Class 2 Permissive Change (C2PC) Request Letter

FCC ID: 2AXDT-RFM017, granted on 07/15/2025.
IC: 26428-RFM017, HVIN(s): RFM017, granted on 07/14/2025.

Reason: Hardware Change

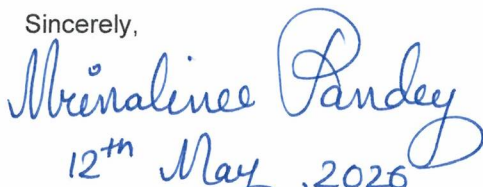
- Part substitution of BALUN filter is caused by product EOL (End-Of-Life), will be replaced with the manufacturer recommended BALUN. The new BALUN component is pin-for-pin compatible and has the same basic function as the BALUN (from an external perspective). No PCB change and No change in radio parameters have occurred, verified by RF Performance and Emission test conducted by FCC accredited Lab.
